# PRICE RIVER COAL COMPANY

Re: Compliance with remaining permit conditions

The following responses should address the final four permit conditions Nos. 1, 2, 9 and 11.

Figure 3.3-15

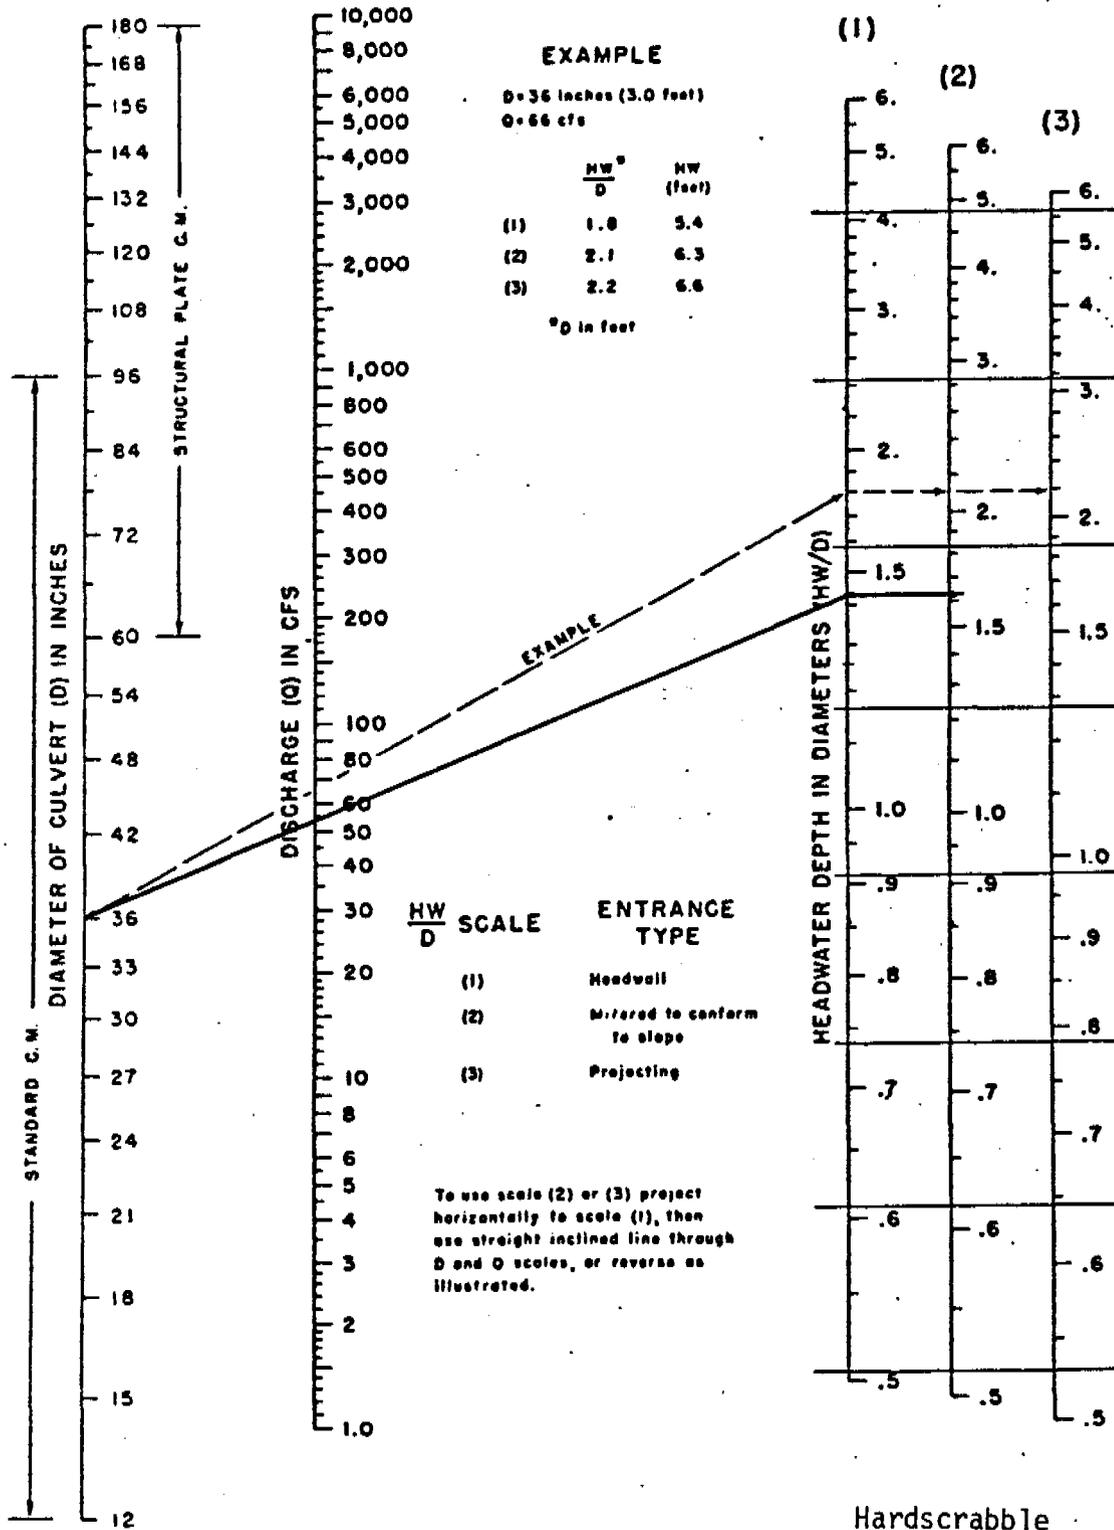
##### Culvert C-3 - For undisturbed drainage area HC-3

Try 36" cmp with 5' H.W., mirrored headwall  
(see attached nomograph; Figure 3.3-15)

Flow capacity about 54 cfs; adequate

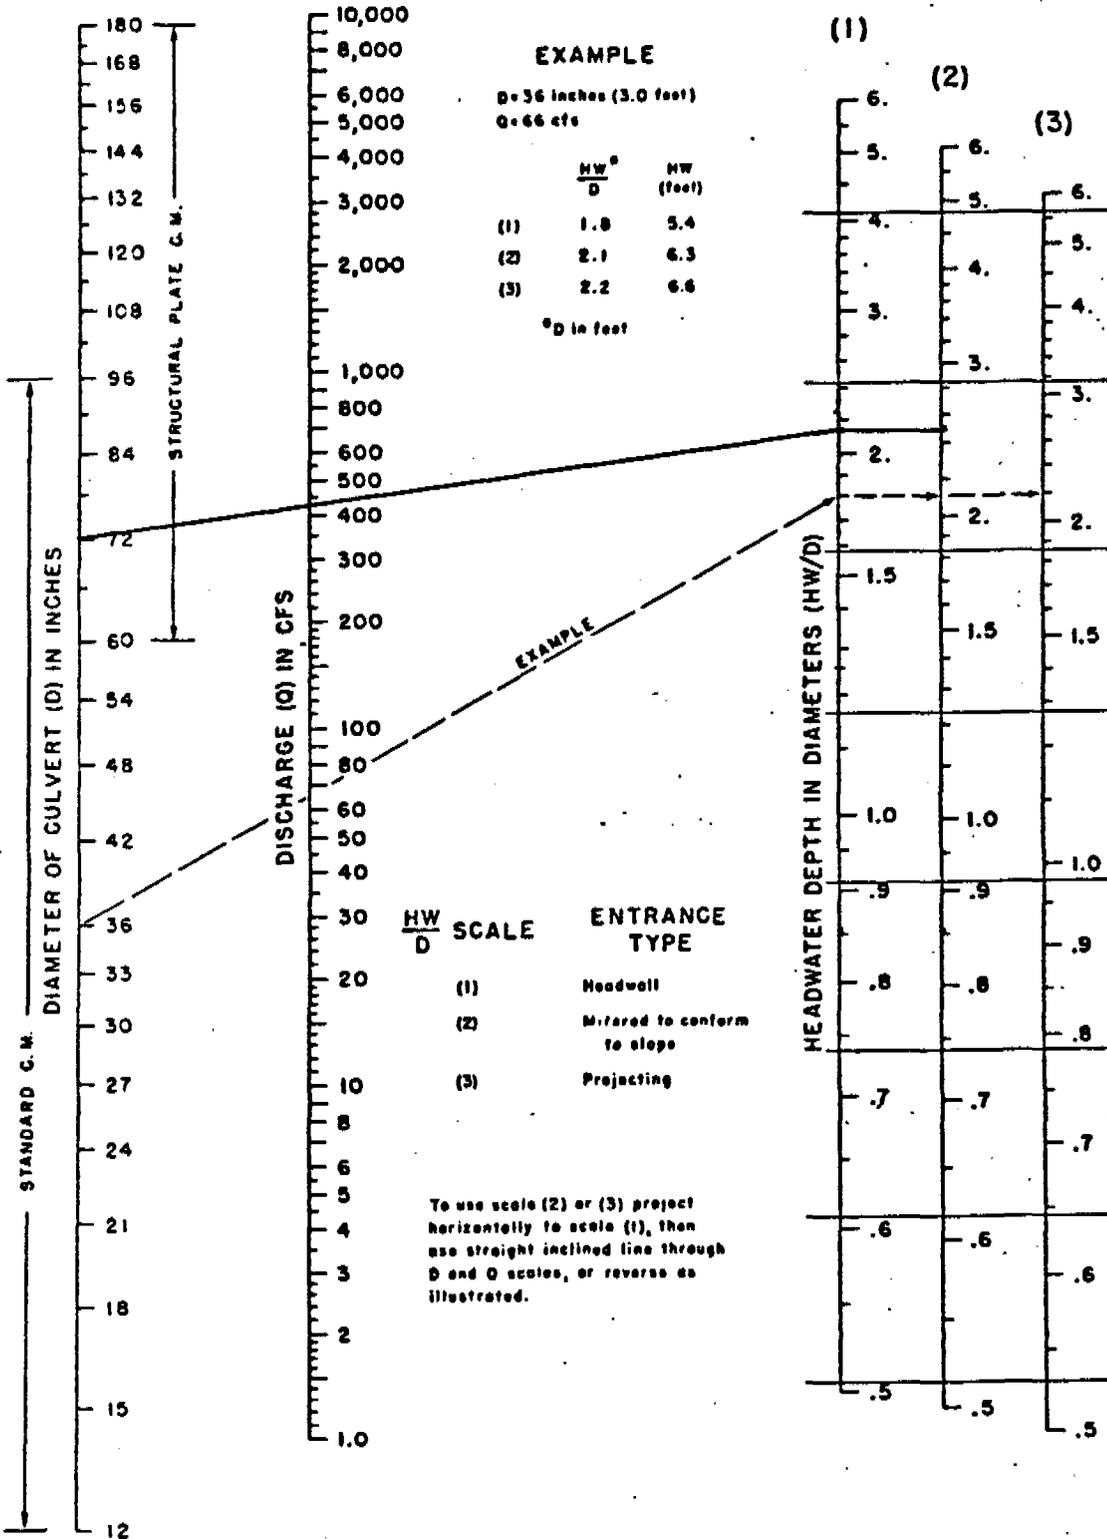
##### Culvert C-4 - For undisturbed drainage areas HC-9, 4, 5, 3, 8

Try 72" cmp with 15' H.W., mirrored headwall  
(see attached nomograph; Figure 3.3-13)

Flow capacity about 425 cfs; adequate

PORTAL SEALING

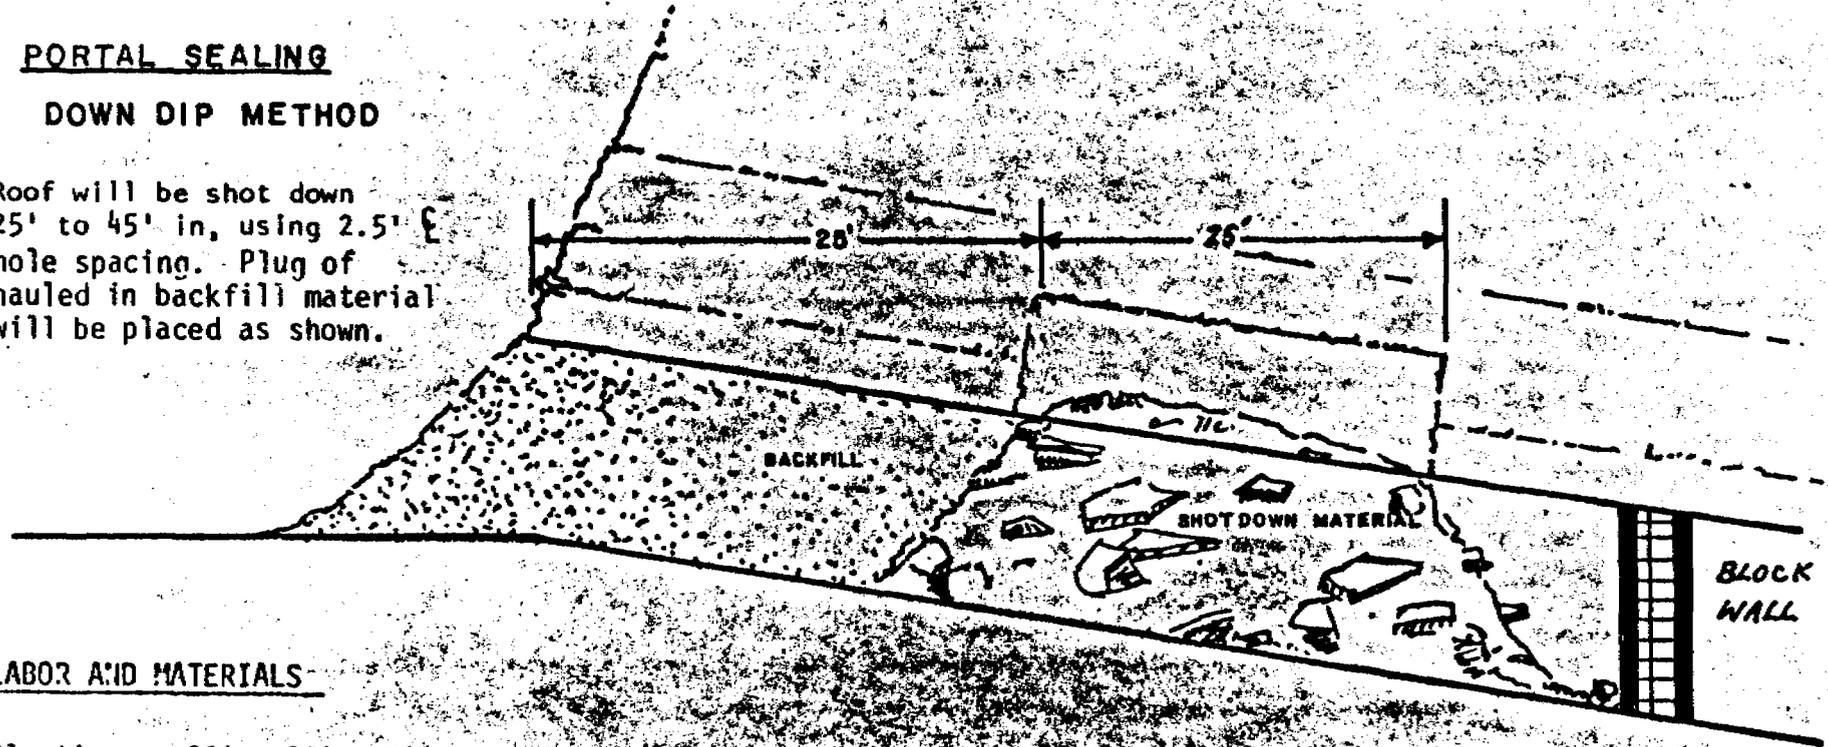
The portal sealing plan included in PRCC's MRP (pp. 3-62, 3-63) has been reviewed with BLM's Allen Vance in the Price Utah office (11-84) and is changed according to the attached replacement Figures 3.1-3 and 3.1-4.

Roof will be shot down 25' to 45' in, using 2.5' hole spacing. Plug of hauled in backfill material will be placed as shown.
